DEPARTMENT OF TRANSPORTATION - District 4 Toll Bridge Program 333 Burma Rd.
Oakland, CA 94607
(510) 622-5660, (510) 286-0550 fax

Contract No. 04-0120F4 04-SF-80-13.2 / 13.9 Self-Anchored Suspension Bridge Letter No. 05.03.01-001305

Schedule Review for January 2008

The Department has completed review of Submittals ABF-SUB-000557R00, "Project Schedule Revision No. 16," (Primavera file "ABF.U16.R0.012008.xer") and ABF-SUB-000558R00, "Project Schedule Status No. 16," (Primavera file "ABF.U16.S0.012008.xer").

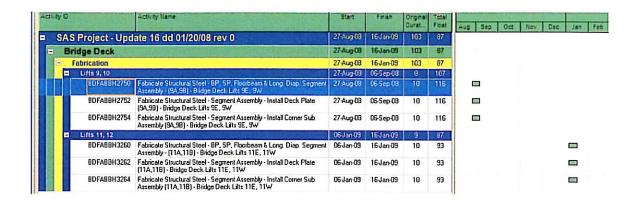
- C1 The secondary responsibility code for construction activities of Temporary Towers A, B and C that will be performed by Traylor-Dutra is inaccurate. Review and revise accordingly.
- C2 The Traylor-Dutra schedule provided in ABF-TRN-690 does not show that the east and west foundations for Temporary Tower A will be constructed simultaneously as shown in the January update. Review and revise accordingly.
- C3 The current resources associated with Temporary Towers A and B appear to be incorrect. Review and revise accordingly.
- C4 The December 2007 update schedule showed that Temporary Towers A through G east and west and Trusses A through G east and west were going to be constructed prior to the construction of the T1 erection tower base. The January 2008 revision schedule shows that there is a change in the

erection sequence, such that Temporary Towers A through G east and west and Trusses A through D will be constructed prior to the erection of the T1 erection tower base. This change in construction sequence was not included in the narrative. Provide the reasoning for this change and in future, include any and all changes to the temporary tower erection sequence in future narratives.
